Product hierarchy no. *				Part no.	SBU	Type / Description	Customer part no.
SBU	PG	PUG	Type				
02	005	016	0000001210	See list below	Power Entry Module	6762 (snap-in)

2 Type of change

Product Change Notification						PCN 6762 (snap-in)	
owner	creation date	release date	released by	change order no	rev	page	D10-039-976
huberth	25.09.2019	01.10.2019	limachcl	2018434	A	1 of 1

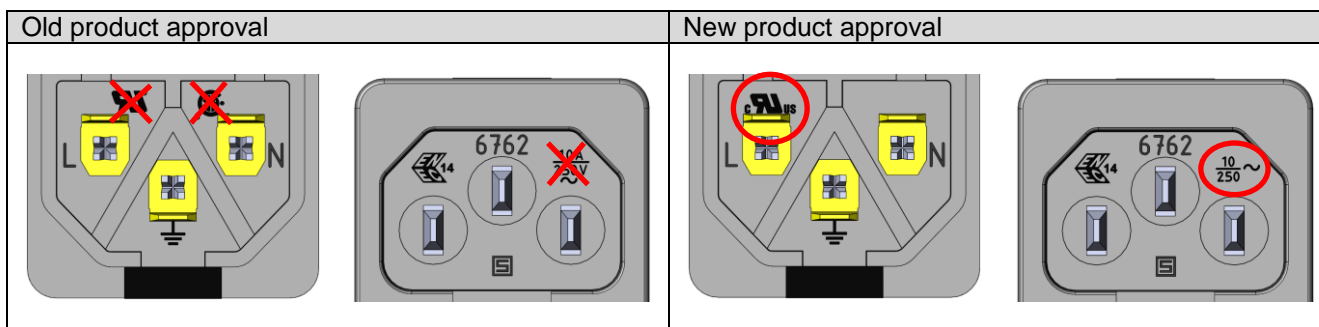
Change of approval markings from UR and CSA to the combined cURus on the product socket.

Form	Yes	Socket new with cURus approval marking
Fit	No	-
Function	No	-
Manufacturing	No	-
Label	No	-
Packaging	No	-
